[REPLACEMENT OF TURBO WITH REF: 5303-970-0139 y 132](#)

TECHNICAL DATA SHEET 2009026

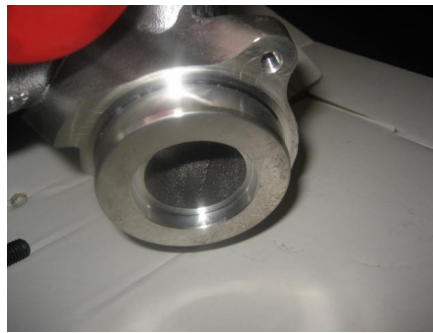
You may observe some differences between the intake pipes in the air pressure outlet zone.

The turbo has been technically modified so that the former reference 5303-970-0132 has now been replaced by the current reference 5303-970-0139.

Both turbos are compatible, however you are now fitting the latest reference on your vehicle. You need to mount the silencer with original reference 03L131111E.
